SERVICE BULLETIN 19092602

MODELS COVERED: 55PFL5604/F7, 55PFL5704/F7

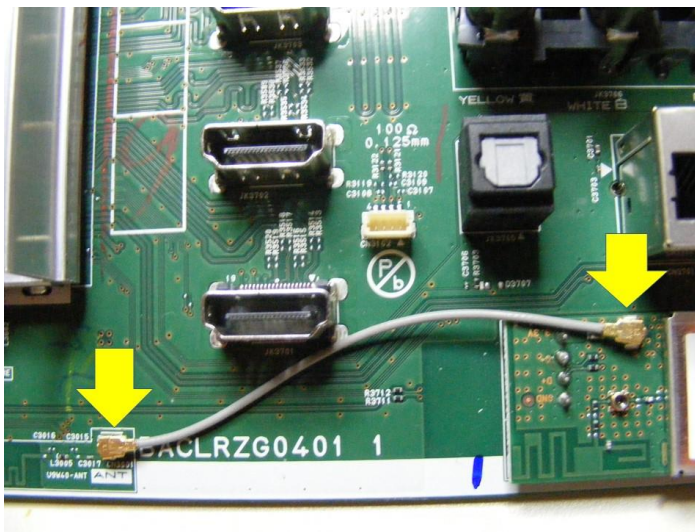
When replacing the Digital Main, the antenna cable must be removed from the defective board installed on the replacement board.

Failure to move the cable will result in the lack of range for the microphone.

If the cable is missing order replacement cable WX1ACLRZW611.
